UNITED STATES ENVIRONMENTAL PROTECTION AGENCY

Re: Petition to use low mass emission methodology for Calvert City CoGen, (Facility ID ORISPL 55308).

EPA has reviewed your November 22, 2002 petition under §75.66(a) in which Air Products and Chemicals, Inc. (Air Products), requested to use low mass emissions (LME) methodology for monitoring nitrogen oxides (NO_x) at two natural-gas-fired boilers at Calvert City CoGen. EPA approves the petition with certain conditions, as discussed below.

Figure 1. Plant Overview

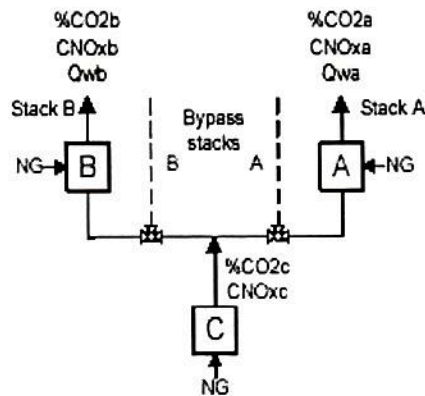
As shown in Figure 1, the current monitoring equipment includes a continuous emission monitoring system (CEMS) at the combustion turbine exhaust ductwork (carbon dioxide (CO_2) % and NO_X concentration) and a NO_X CEMS at each of the main stacks (CO_2%, NO_X concentration and flue gas flow). The turbine and both boilers are also equipped with natural gas flow meters.

However, both Units A and B simultaneously receive exhaust gas flow from the combustion turbine (Unit C). It is necessary to segregate the stack emissions of Units A and B from those of Unit C, which also exhausts through the main stacks. Therefore, the specific requests of the petition are as follows:

EPA approves the proposed methodology of determining the fuel-and-unit-specific NO_X emission rates of Units A and B with the following conditions:

1. The fuel-and-unit-specific 95[th] percentile NO_X emission rate for each boiler will be based on quality assured data from all modes of operation when the boiler is burning natural gas with or without any contribution from the combustion turbine.
2. Any future fuel-and-unit-specific NO_X emission rates, which must be determined in accordance with §75.19(c)(1)(iv) and this letter, shall be based on quality assured data and also reflect all modes of operation of the boiler, including when the boiler is burning natural gas with or without any contribution from the combustion turbine.
